**NOTIFICATION OF ADDENDUM
ADDENDUM NO. TWO
DATED: June 22, 2021**

PR South, Inc. on behalf of Northwest Williamson County Municipal Utility District No. 2

**Parmer Ranch, Phases 2, 3, & 4 Drainage, Paving, Wastewater and Water System
Improvements
City of Georgetown Williamson County, Texas**

Project Number:	22223/01
SCALE:	AS NOTED
Project Path:	P\22000-22999\22223
Project Name:	Parmer Ranch
Drawing Path:	Drawings\Plans
Xref DWG FILE:	
Sheet Number:	21 of 65 sheets

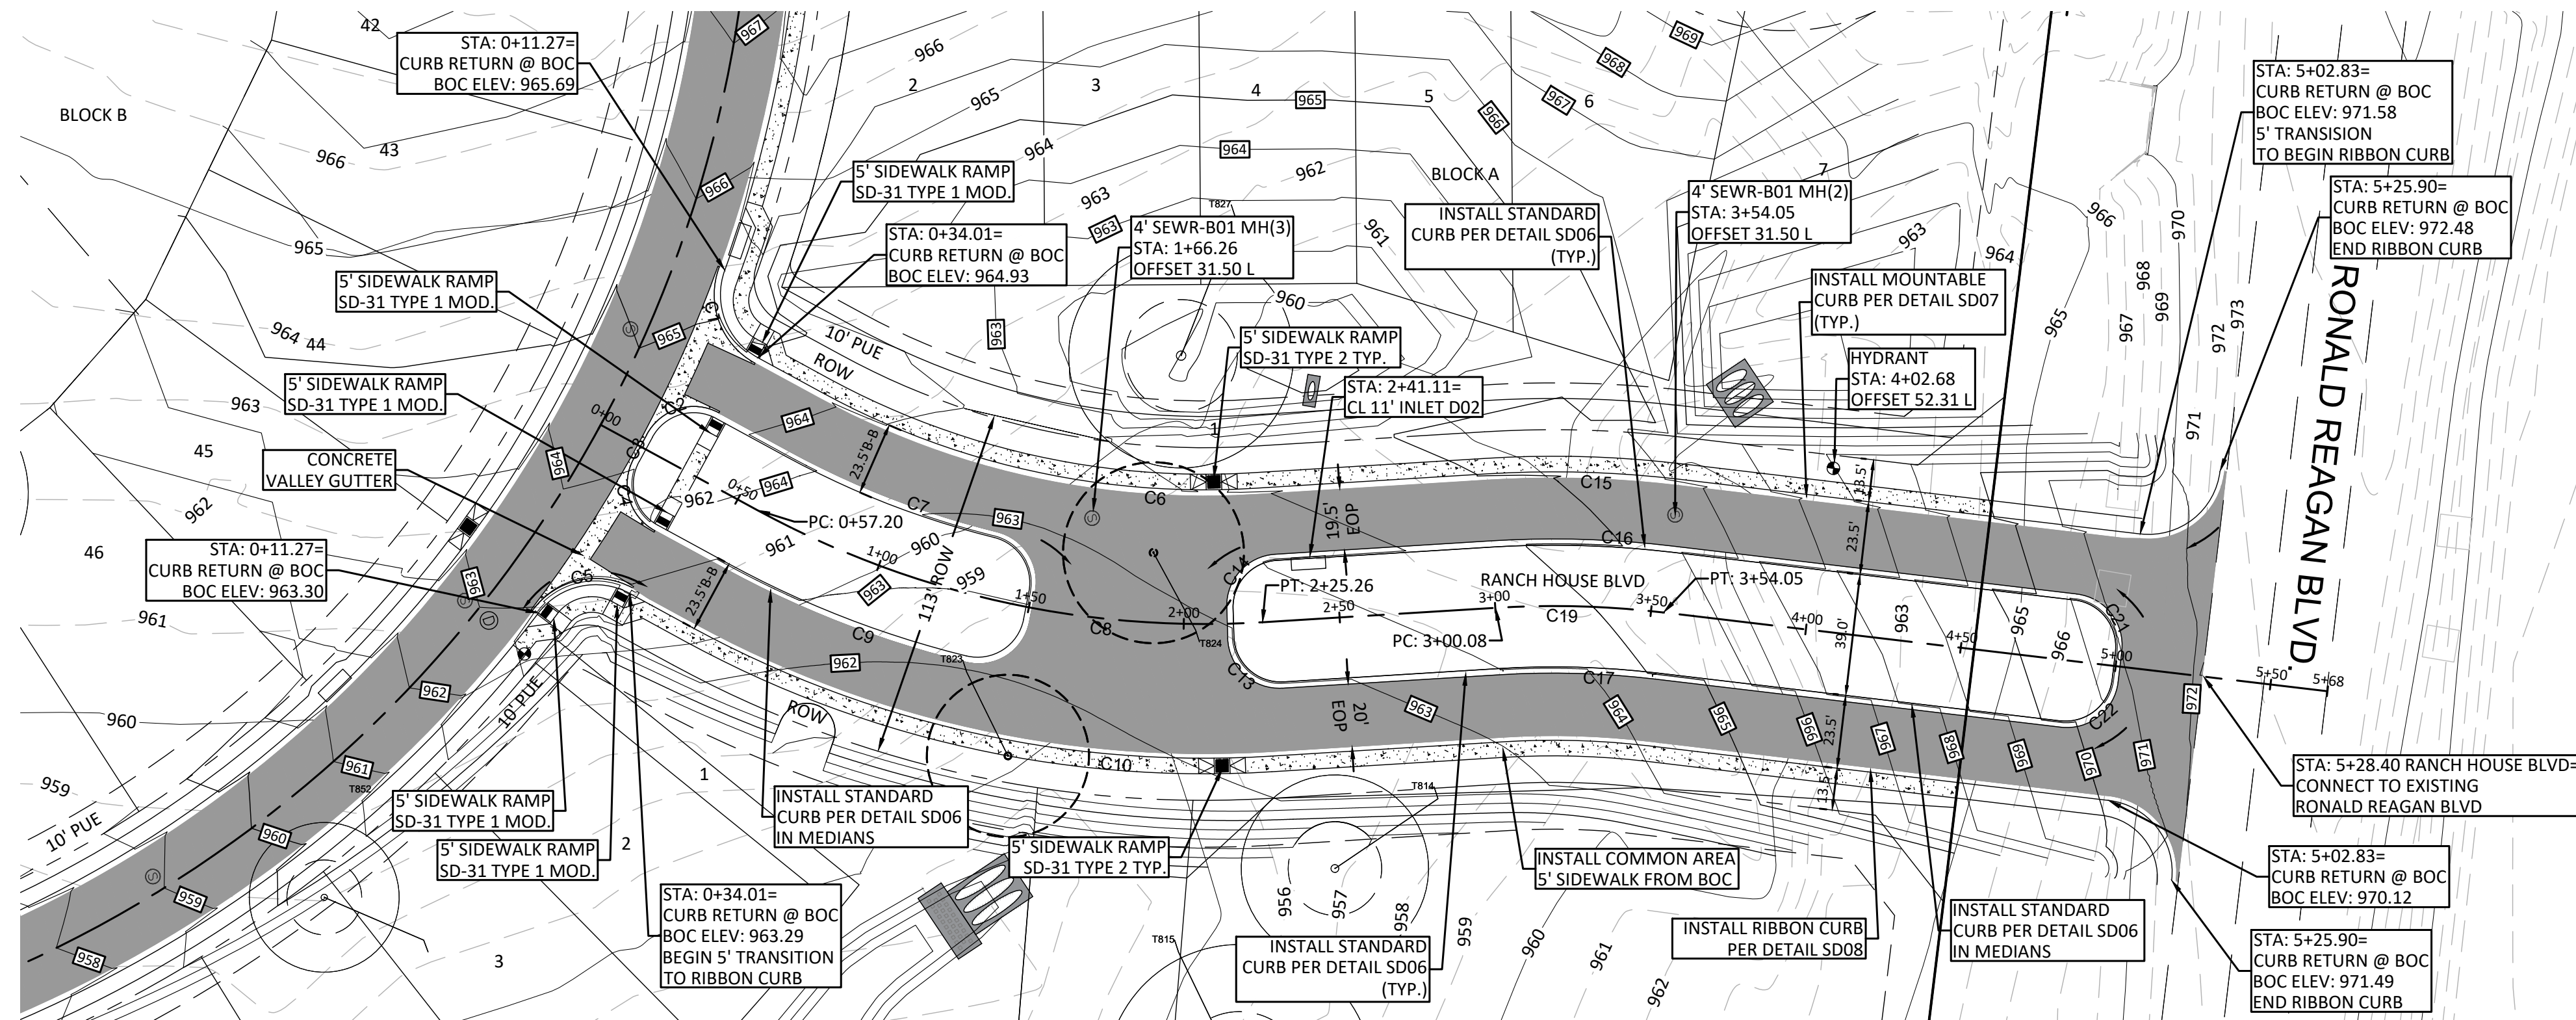
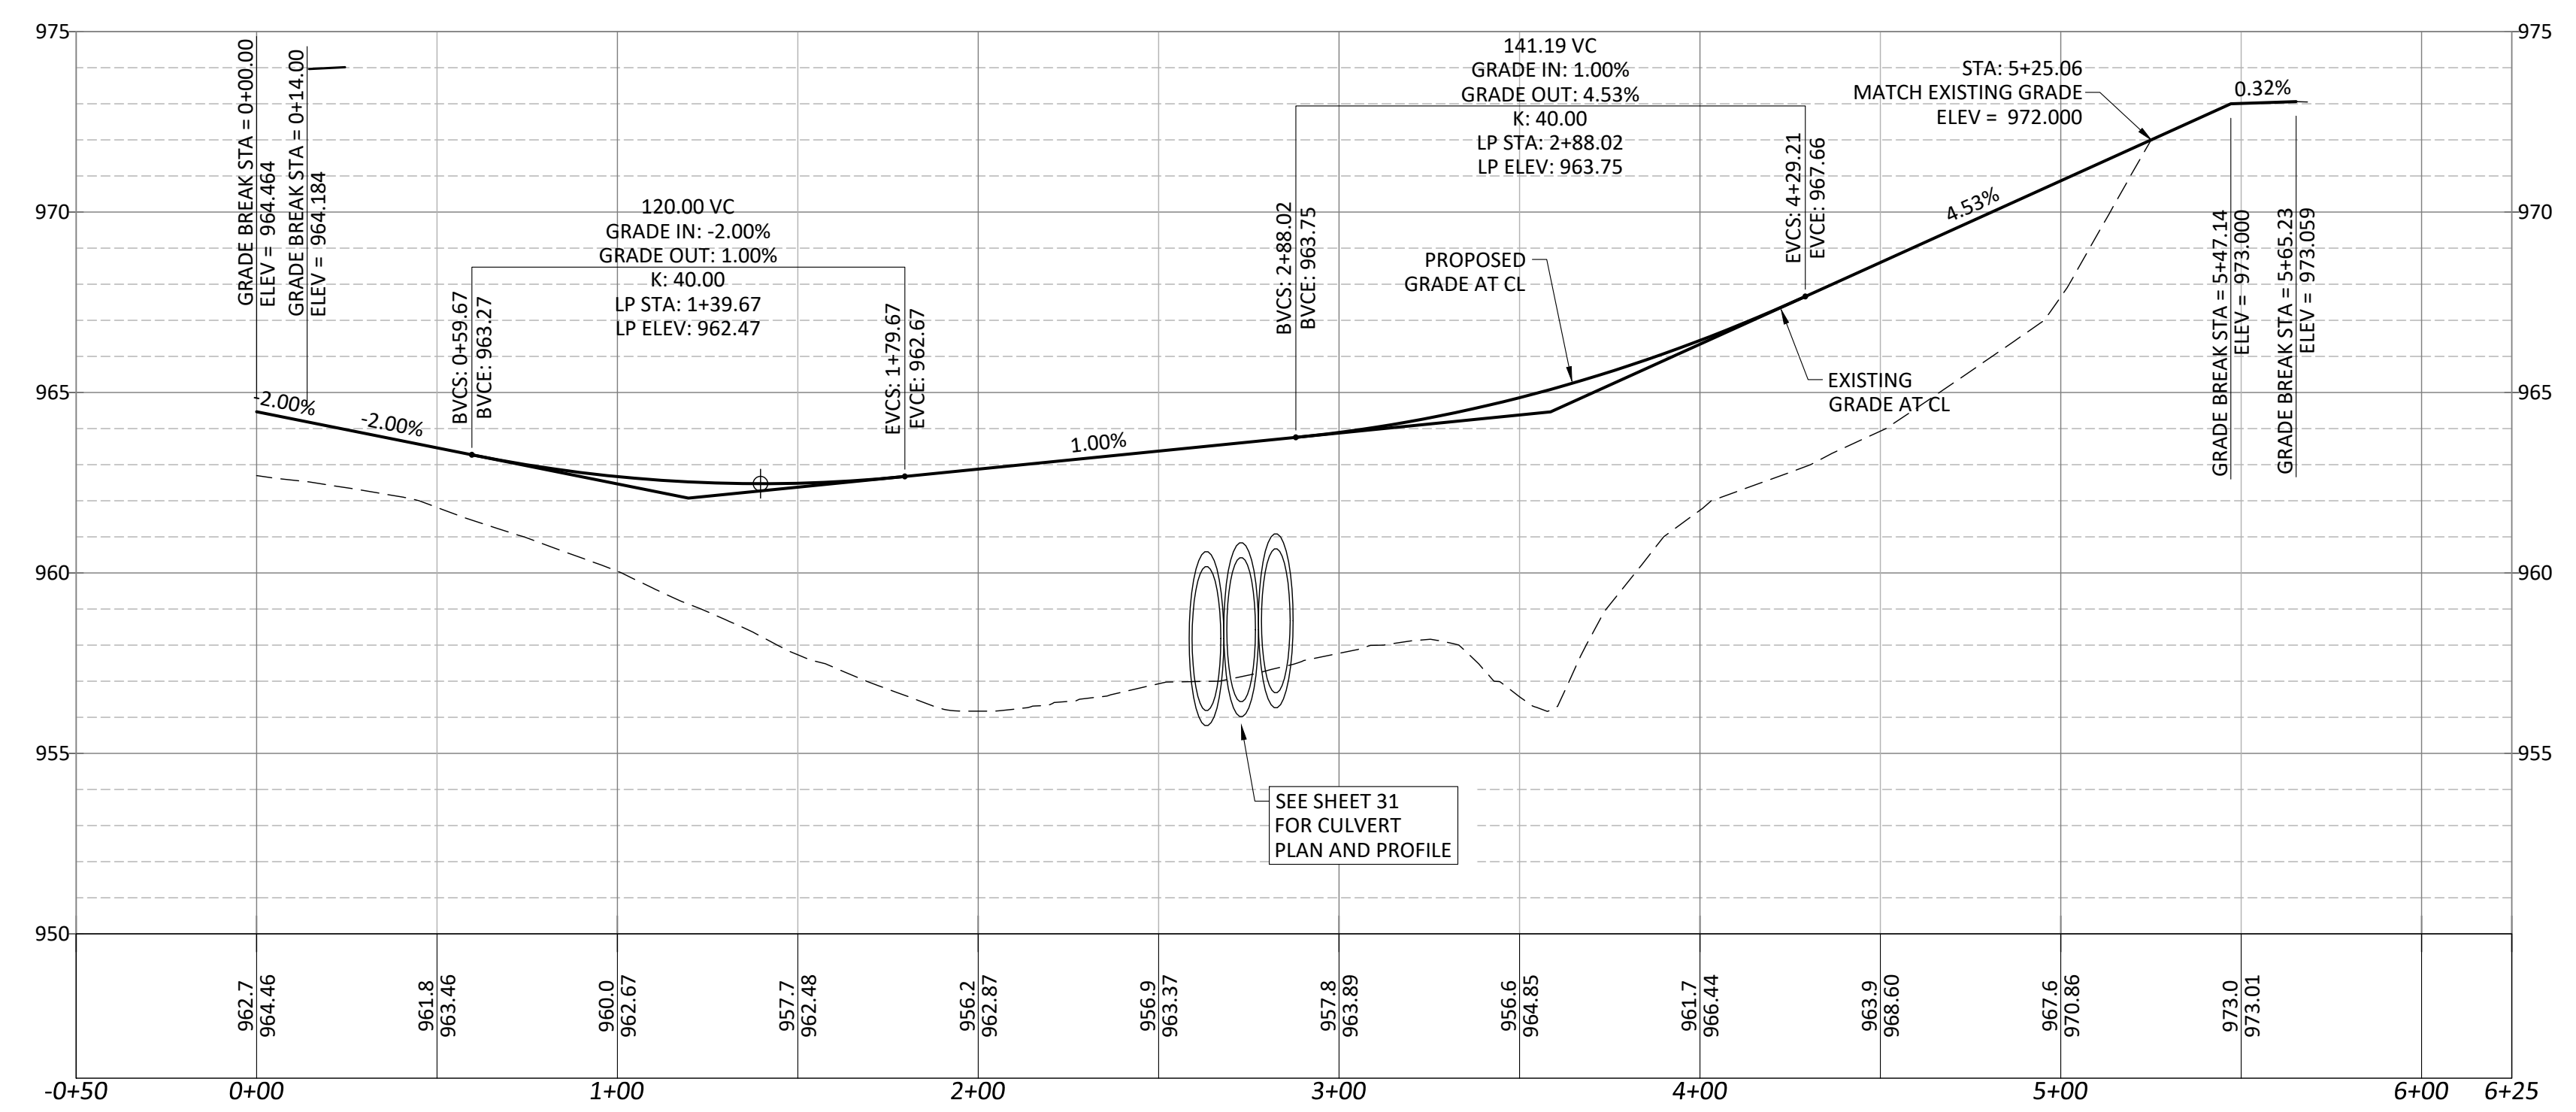
6. I'm not sure I'm understanding the ribbon curb quantity on the bid form and the plans aren't very clear either. Could we get a little more information on the ribbon curb limits?
The ribbon curb is along the southside of Ranch House Blvd and also at the return radius on the north side. Additional labels have been added to Sheet 21.
